NUCLEAR REGULATORY COMMISSION

ADVISORY COMMITTEE ON REACTOR SAFEGUARDS

SUBCOMMITTEE MEETING

SEQUOYAH NUCLEAR PLANT

UPPER HEAD INJECTION SYSTEM FLOW DIAGRAM

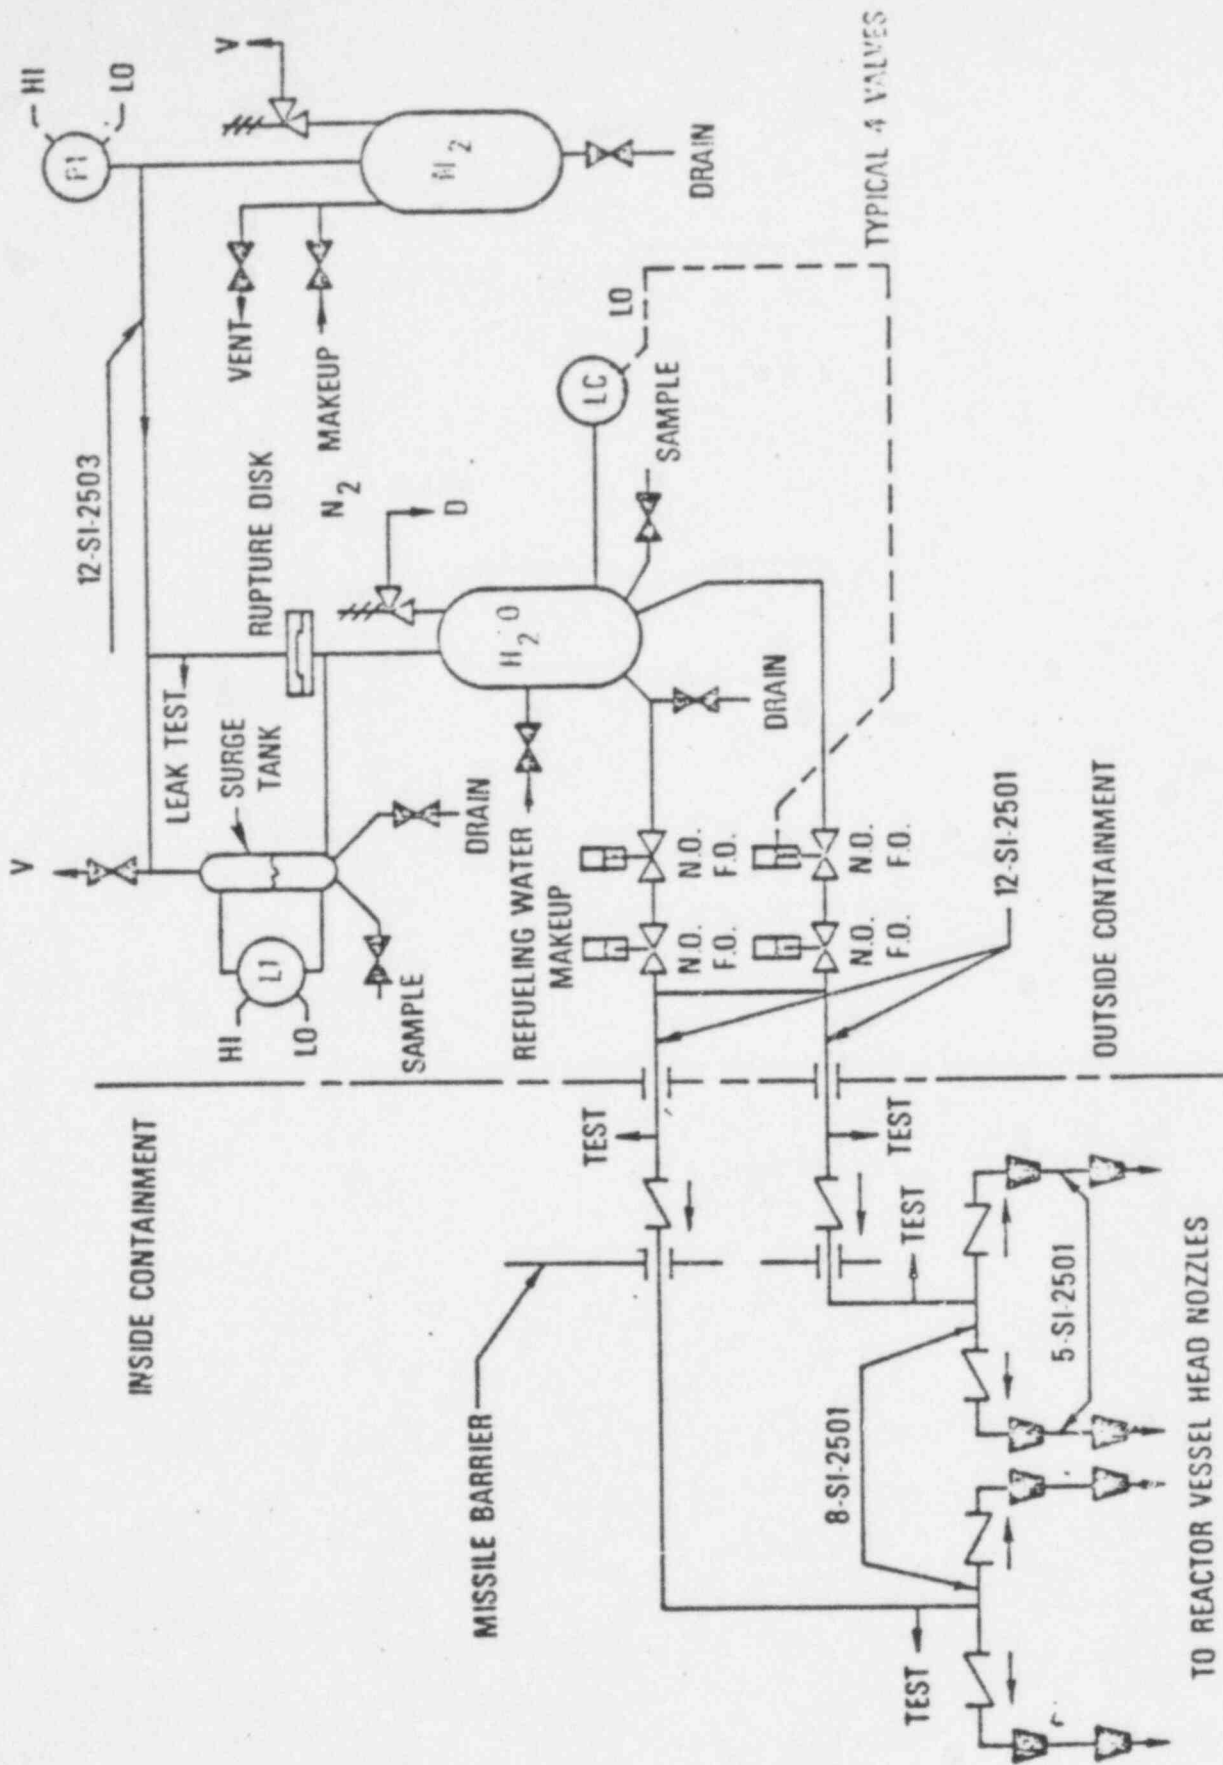
4 MR. CATTON: I notice it says here the Sequoyah
5 upper internals have been modified to incorporate UHI.

7 MR. CATTON: You mean Sequoyah was not originally
8 planned to have injection?

14 I am not sure how to define the difficulties; but,
15 yes, the upper head had to be modified and there had to be a
16 considerable amount of design work in the modification of
17 the reactor vessel and of the piping systems, so forth;
18 everything that is associated with adding on a major piece
19 of hydraulic systems.

Figure 6.2-94 Schematic Diagram of Leakage Paths

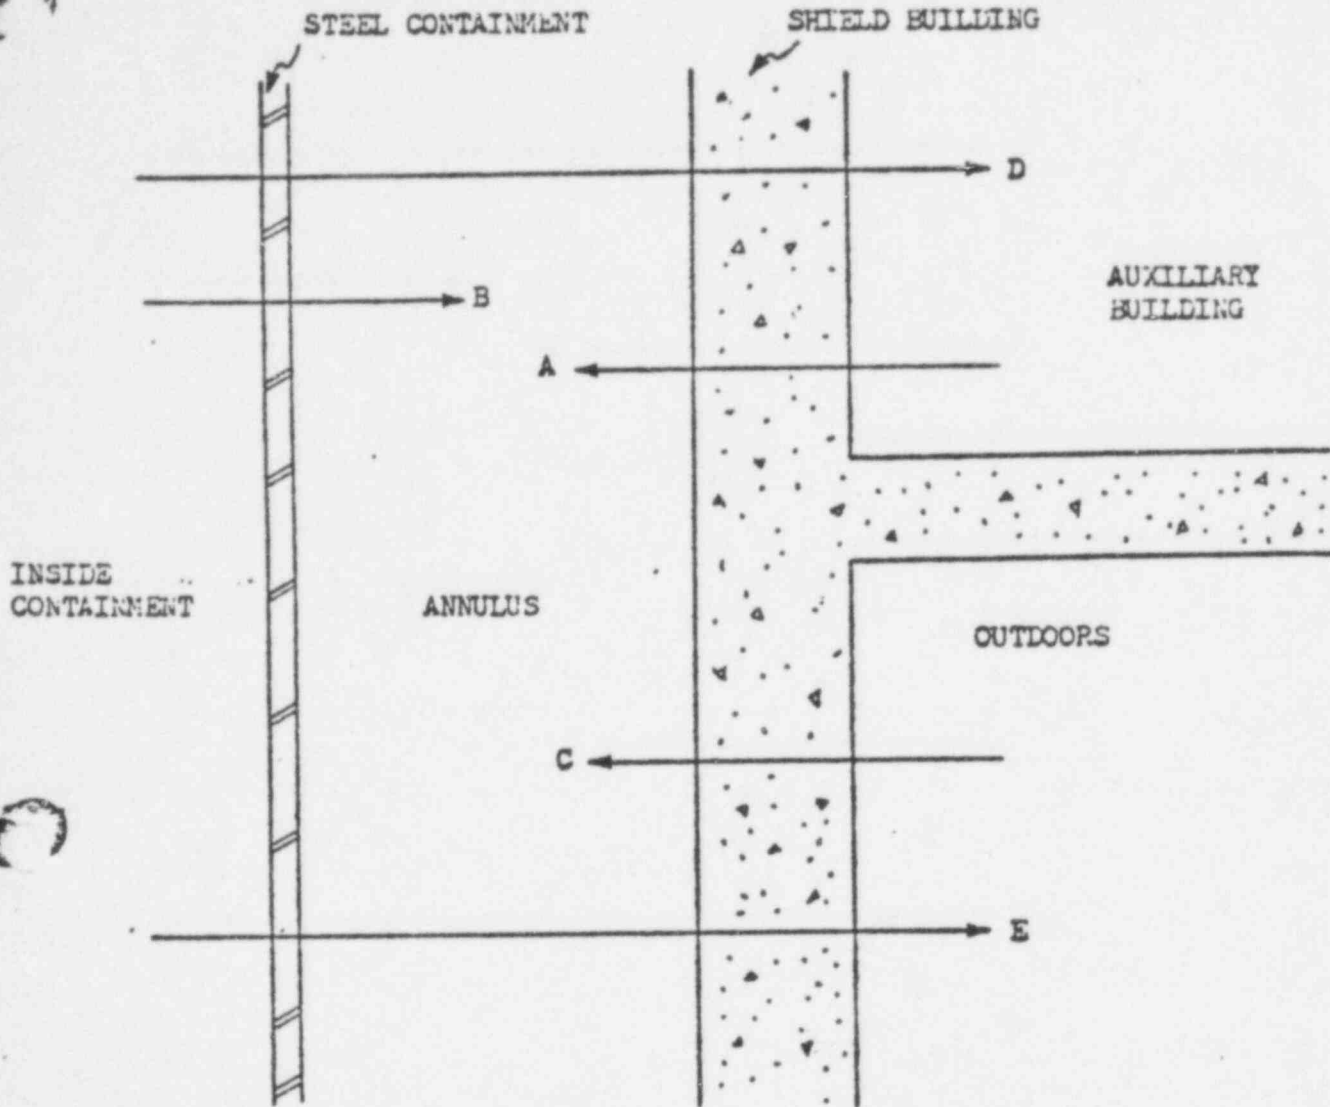
Figure 6.2-94 in the FSAR shows the primary containment, the annulus, the auxiliary building and outdoors.

Figure 6.2-2 Typical Purge Penetration Arrangement

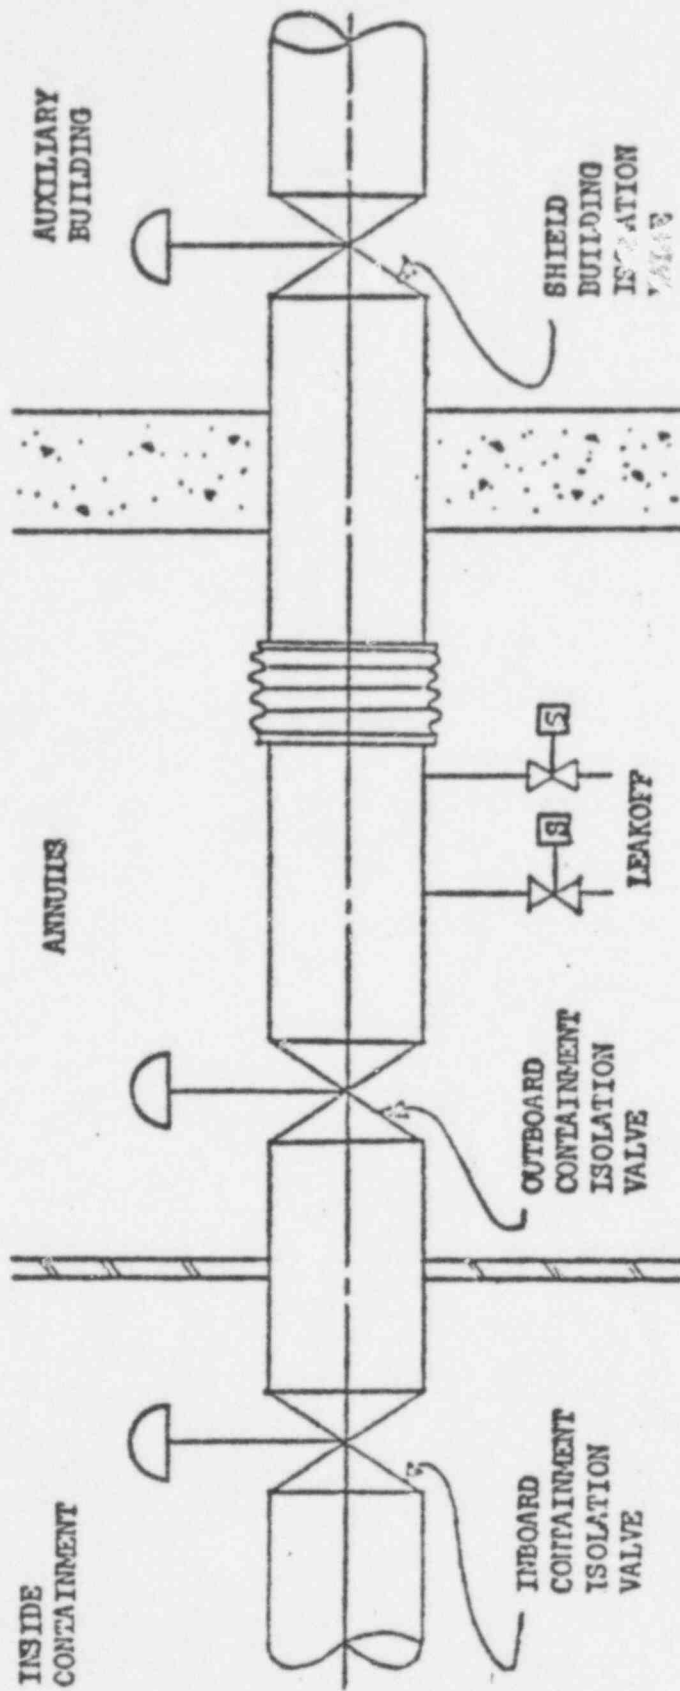
10 Figure 6.2-2 in the FSAR shows as an example
11 what we seek in our design to eliminate secondary containment
12 bypass.
